DOCUMENT CHANGE REQUEST

DCR number 271 Changes required for: General

Title: Diodes, Power Rectifier, Schottky Barrier, based on type STPS20100

Number: 5106/016

1.7.2 Surface Mount Package (SMD.5) - 3 terminal

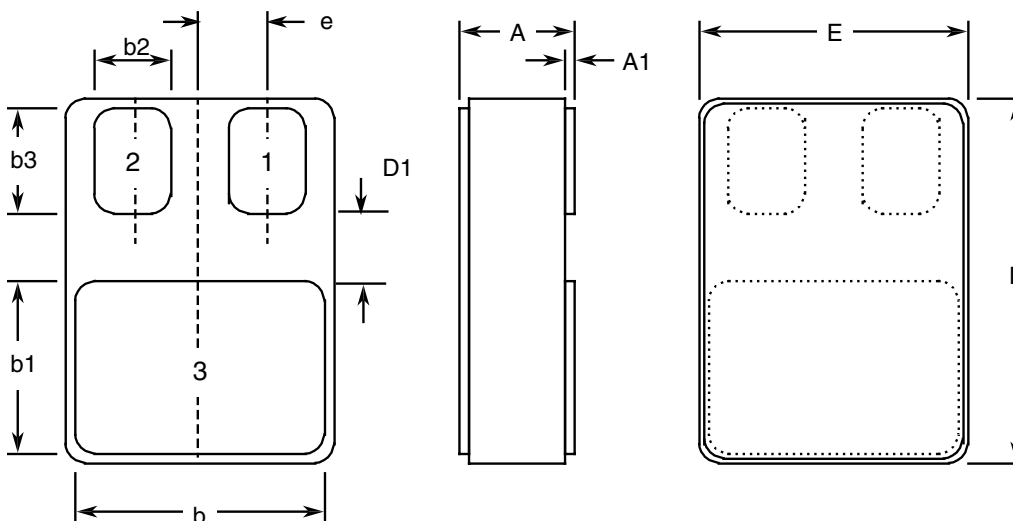
1. Rewording and restructure of various sections and paragraphs of the specification plus other editorial changes based on the layout and editorial content of other Detail Specifications already converted to ESCC format.
2. Deletion of any redundant paragraphs and information, e.g. the mechanical paragraph.
3. Table 1(b) . .Top. rating added and Pulse Condition for .VRRM . rating added.
4. Figure 1 Parameter Derating Requirements - moved to be a note to the Maximum Ratings table.
5. New paragraph for Beryllium Oxide handling precautions added for type variants with the TO-245 package.
6. Figure 2(a) - Dimensions .H., .J. and .K. corrected from "Typical" to "BSC". Dimension .I. corrected to .fl. and .M. to .fM..
7. Figures 2(b) and 2(c) . Dimension .e. corrected from "Typical" to "BSC".

Symbols	Dimensions mm		Notes
	Min	Max	
b3	2.92	3.18	5
D	10.03	10.28	
D1	0.76	-	5
E	7.39	7.64	
e	1.91 BSC		5
